Subject: Information on Proposed Changes for the AP1000 Design Control Document Rev. 18

Change Number 73

Subject	
Main Control Room Emergency Habitability System (VES) Minimum Amount of Stored Compressed Air Change and P&ID Flow Instrumentation Clarification	
DCD Sections Impacted	
<p><u>Tier 1:</u> ITAAC, Table 2.2.5-5, Item 7a</p> <p><u>Tier 2:</u> Figure 6.4-2 (sheet 2 of 2), 6.4.2.3, and 6.4.5.1 Table 14.3-7 (sheet 1 of 3)</p> <p><u>Tech Specs (Chapter 16):</u> TS 3.7.6 Item D SR 3.7.6.2 B 3.7.6 BASES SR 3.7.6.2 New figures B3.7.6-1 (1 of 1) and B3.7.6-2 (1 of 1)</p>	
Description of change to DCD/Reason for change to DCD	
<p><u>Description of DCD Change:</u> Change DCD Tier 1 Table 2.2.5-5 and Tier 2 Sections 6.4.2.3, 6.4.5.1, and Table 14.3-7 (sheet 1 of 3) to show 327,574 scf as the minimum amount of stored breathable air for the VES compressed air storage tanks and eliminate references to minimum pressure. Revise Tech Specs 3.7.6. and Bases in DCD Chapter 16 to reflect the change in minimum mass of stored air. Revise Tech Specs 3.7.6 and Bases in DCD Chapter 16 to account for monitoring pressure and temperature to determine mass of air in the tanks. Revise Figure 6.4-2 (sh

Figure B 3.7.6-1
Compressed Air Storage Tanks Minimum Volume

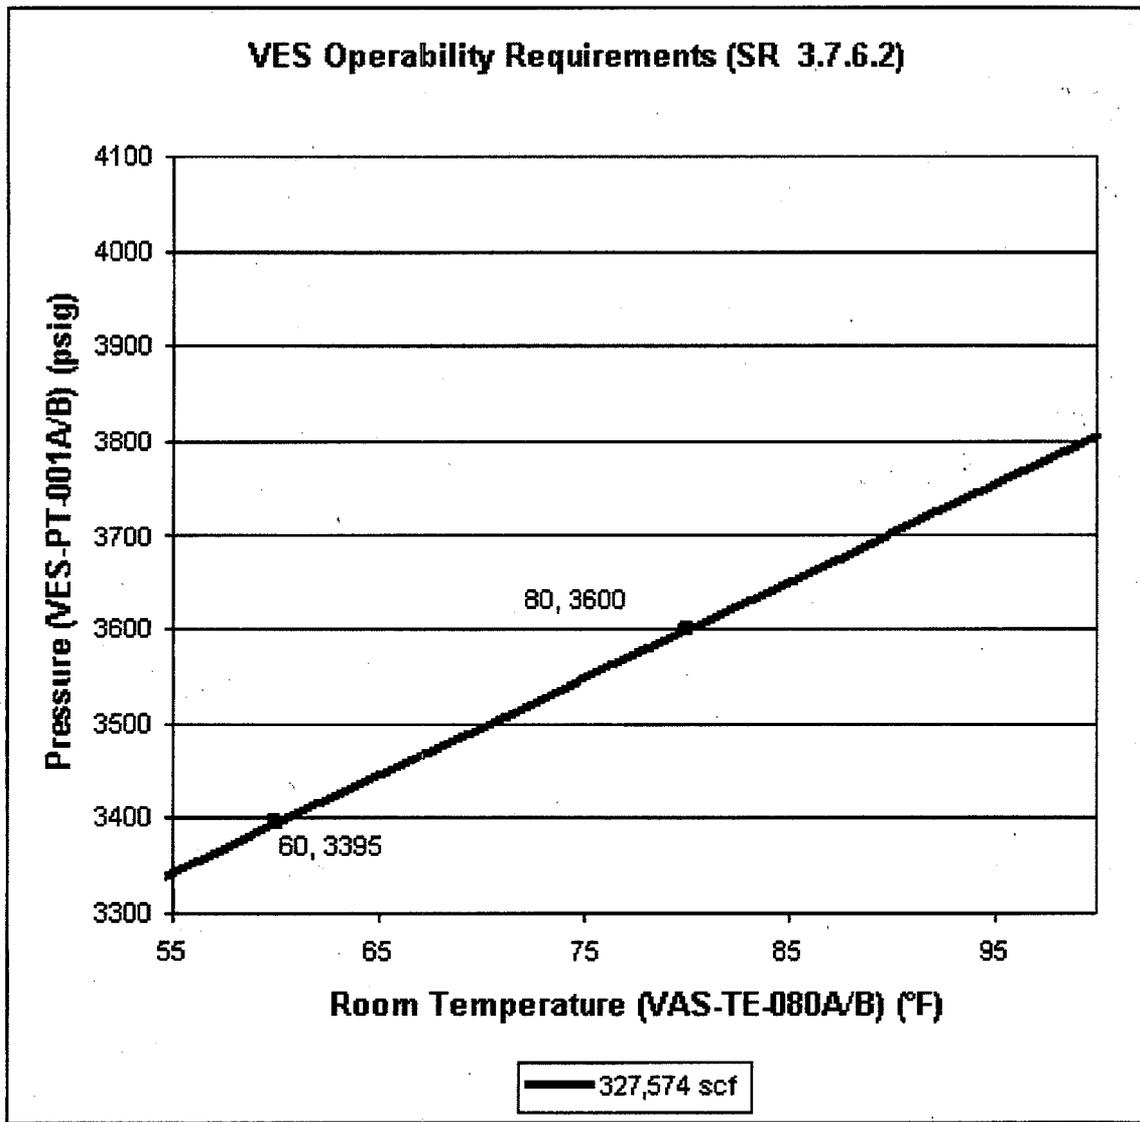
~~are pressurized to \geq 3400 psig is sufficient to~~ The standard volume is determined using the compressed air storage tank room temperature (VAS-TE-080A/B), compressed air storage tanks pressure (VES-PT-001A/B), and Figure B 3.6.7-1, Compressed Air Storage Tanks Minimum Volume. Values above the 327,574 scf line in the figure meet the surveillance criteria. Verification that the minimum volume of compressed air is contained in the compressed air storage tanks ensures that there will be an adequate supply of breathable air to maintain MCRE habitability for a period of 72 hours. The Frequency of 24 hours is based on the availability of pressure indication in the MCRE.

Verification every 24 hours that compressed air storage tanks contain greater than 327,574 scf of breathable air.

Figure B 3.7.6-2
Compressed Air Storage Tanks Minimum Volume – One Bank of VES Air Tanks
(8 Tanks) Inoperable

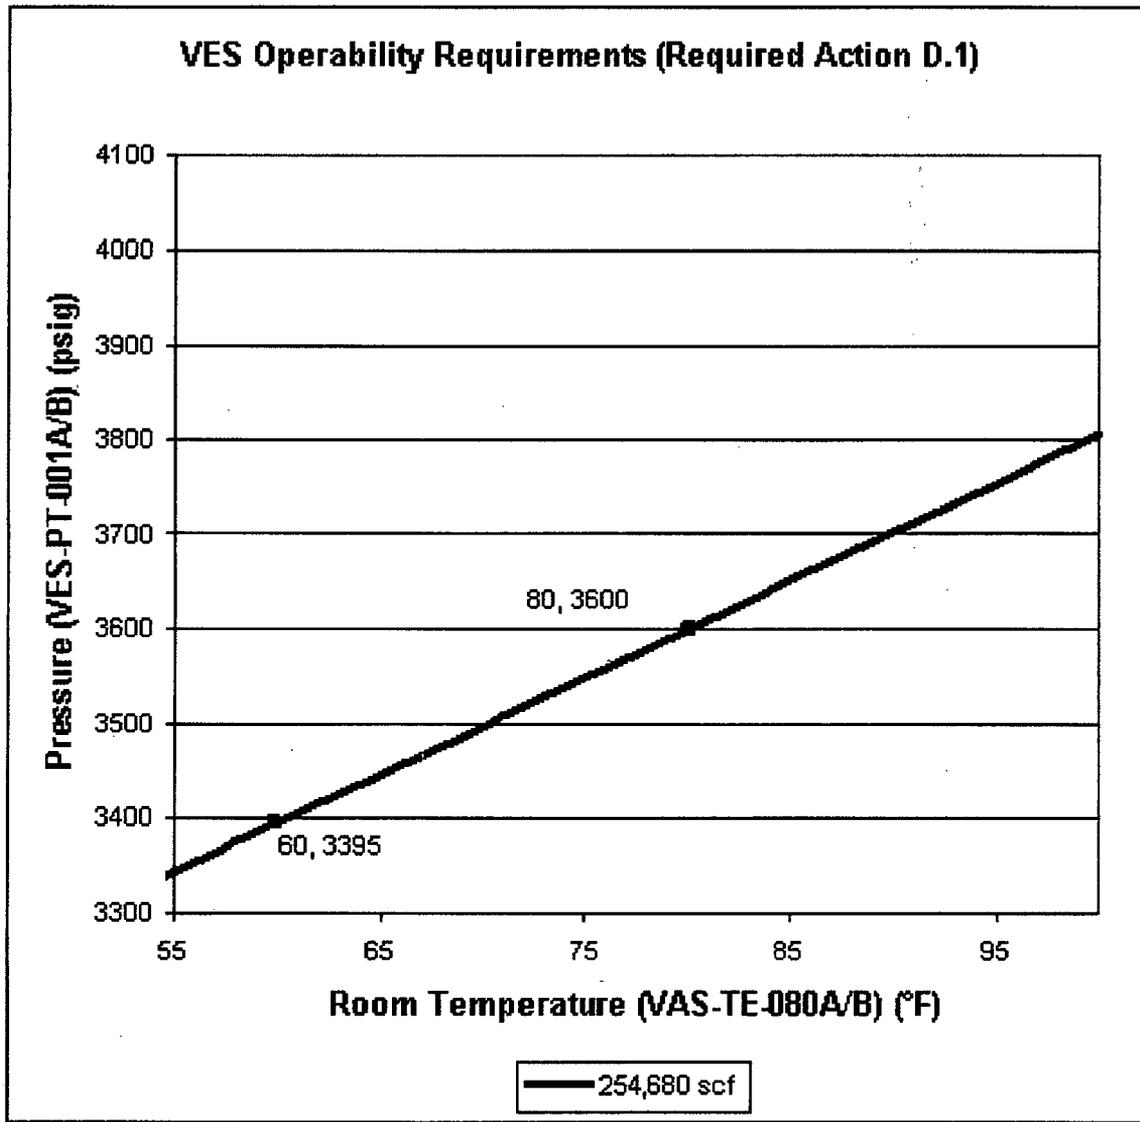
With one bank of VES air tanks inoperable, action must be taken to restore OPERABLE status within 7 days. In this Condition, the stored amount of compressed air in the remaining OPERABLE VES air tanks must be verified within 2 hours and every 12 hours thereafter to be at least 245,680 scf. The 245,680 scf value is 75 percent of the minimum amount of stored compressed air that must be available in the compressed air storage tanks. The standard volume is determined using the compressed air storage tank room temperature (VAS-TE-080A/B), compressed air storage tanks pressure (VES-PT-001A/B), and Figure B 3.6.7-2, Compressed Air Storage Tanks Minimum Volume – One Bank of VES Air Tanks (8 Tanks) Inoperable. Values above the 245,680 scf line in the figure meet the Required Action criteria. Verification that the minimum volume of compressed air is contained in the OPERABLE compressed air storage tanks ensures a 54 hour air supply will be available if needed. Additionally, within 24 hours, the VBS ancillary fans are verified to be OPERABLE so that, if needed, can be put into use once the OPERABLE compressed air storage tanks have been exhausted. The Completion Times associated with these actions and the 7 day Completion Time to restore VES to OPERABLE are based on engineering judgment, considering the low probability of an accident that would result in a significant radiation release from the reactor core, the low probability of radioactivity release, and that the remaining components and compensatory systems can provide the required capability. The 54 hours of air in the remaining OPERABLE compressed air storage tanks, along with compensatory operator actions, are adequate to protect the main control room envelope habitability. Dose calculations verify that the MCR dose limits will remain within the requirements of GDC 19 with the compensatory actions taken at 54 hours.
